Synthetic Review Drawing Stub

Part	Flap tucker arm
Revision	B
Pilot	WEBASTO
Material	42CrMo4

Views

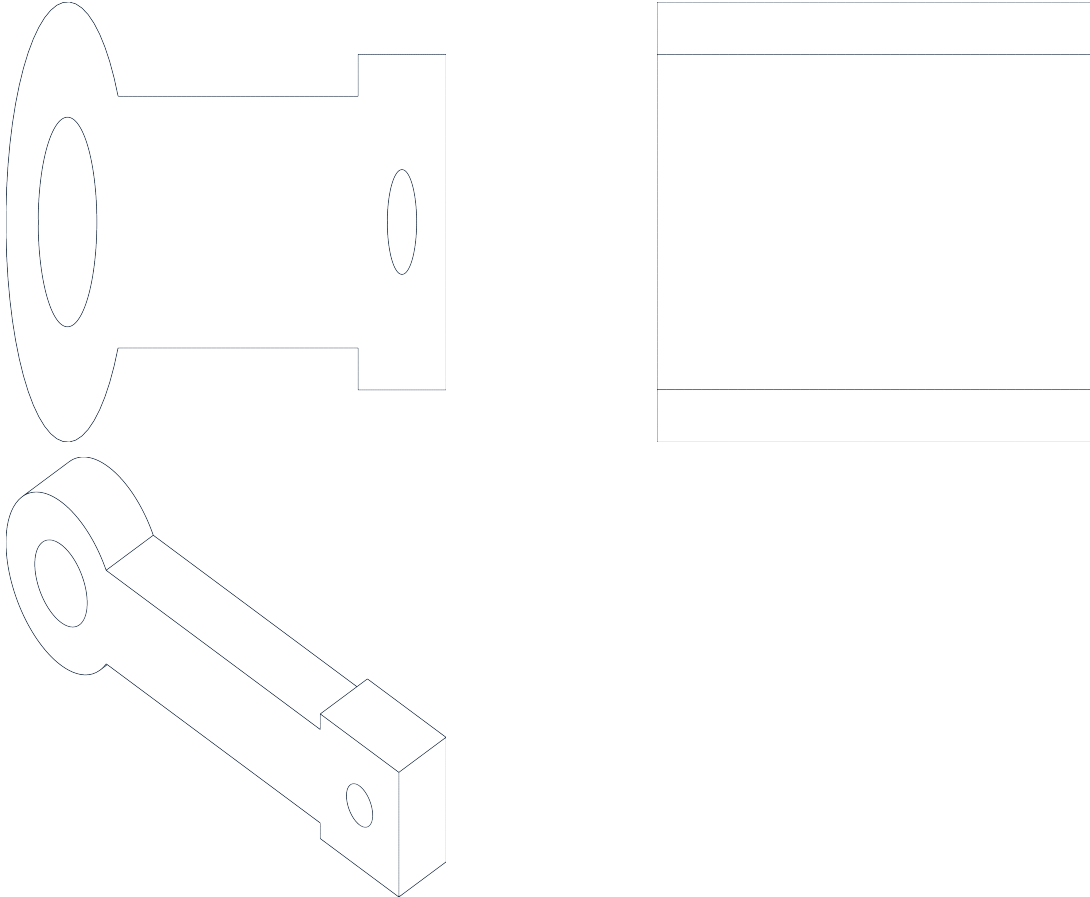
- Shorten the arm by about 6 mm.
- Increase the pivot bore size to represent a hardened bushing insert.
- Refine the lightening pocket to preserve stiffness in the shorter arm.
